Rezoning Transportation Analysis

Petition Number: 2020-013

General Location Identifier: 14902504, 14902503

Date	Description
02-24-20	First Review (EL)
08-19-20	Second Review (KP)
09-17-20	Third Review (KP)
10-16-20	Fourth Review (KP)

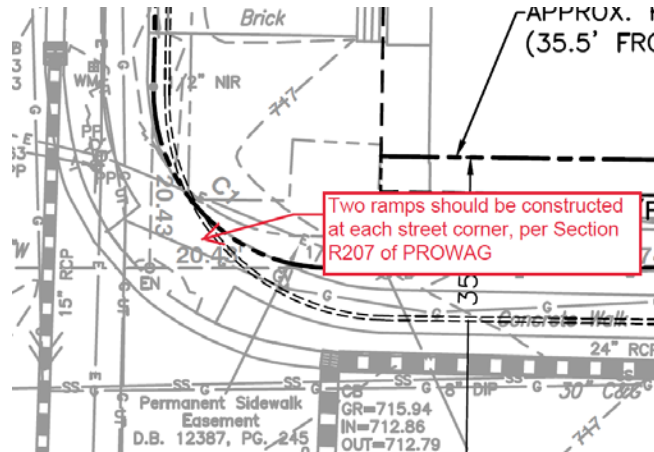
5. Revise the site plan and conditional note(s) to commit to construct an 8-foot planting strip and 8-foot sidewalk, per the Scaleybark Transit Station Area Plan, with respect to the future curbline, along both South Tryon Street and East Cama Street. The Scaleybark Transit Station Area Plan remains as the reference for the streetscape requirements for this proposed rezoning.

Updated Comment: Will need to update future back of curb along Cama Street to approve this comment.
